E8357A-03A

**S E R V I C E N O T E**

E8357A PNA Microwave Network Analyzers

**Figure 2: A3 Front Panel Interface Board Assy with the Bracket Installed**

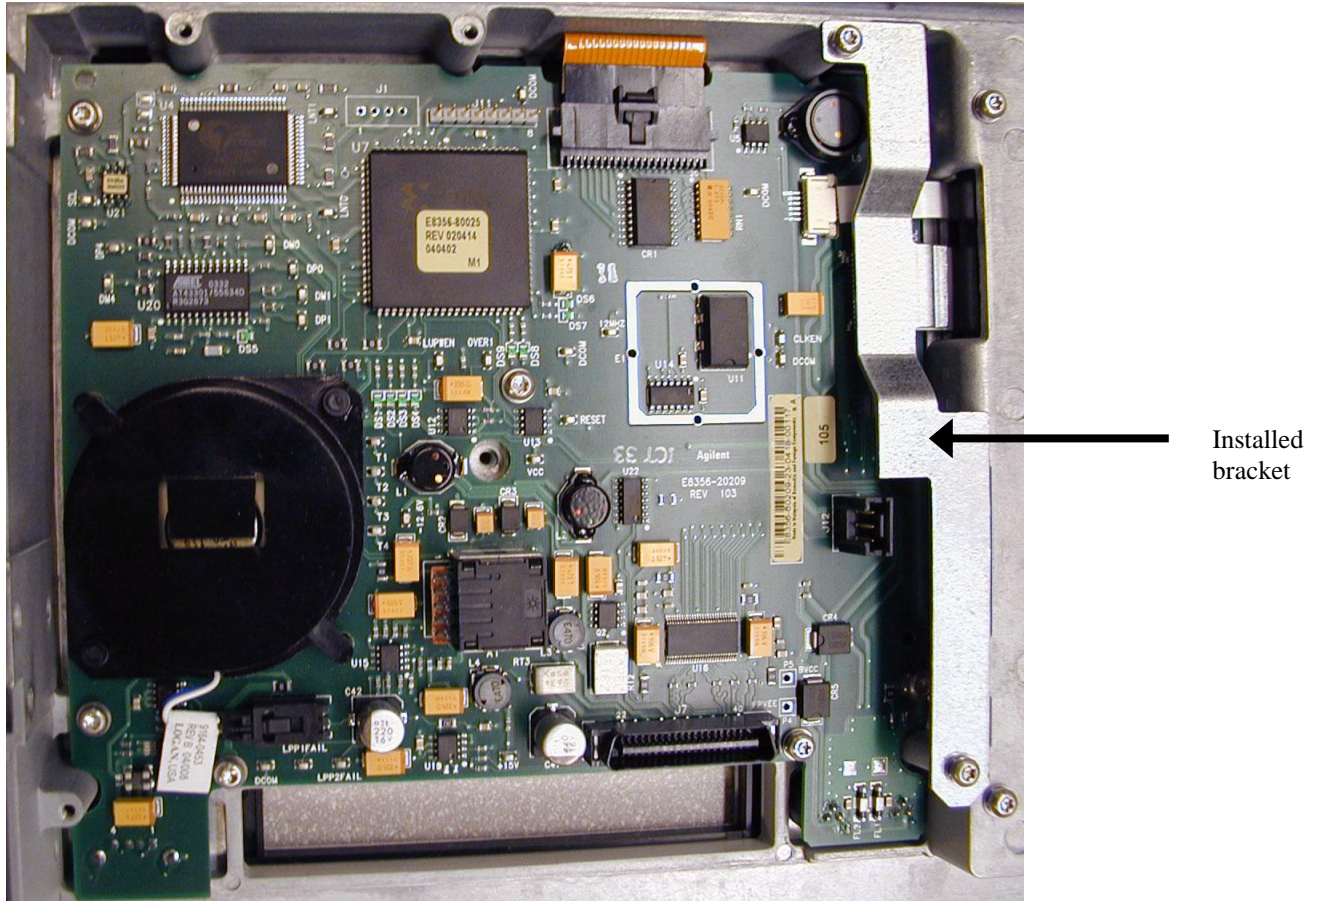
A connector of the ribbon cable (Agilent part number 8120-8409) that joins the front panel display to the front panel interface board can loosen, causing a display failure, unless a new bracket is installed. Because the failure rate has been very low, *it is recommended that the bracket be installed only when there is an additional reason to remove the PNA front panel.*

1. Refer to Figure 1 in this document:
  - Press down firmly on the ribbon cable's black connector.
  - Locate the two tapped holes for the bracket screws.
2. As shown in Figure 2 in this document, position the bracket so that its holes line-up with the two holes you located in the previous step.
3. Hand-start the two screws, and then torque both to 9 in-lbs.
4. Reinstall the PNA Front Panel by following the Service Guide instructions in the "Replacement Procedure." This is located on the same page as the "Removal Procedure" used previously in step 7.
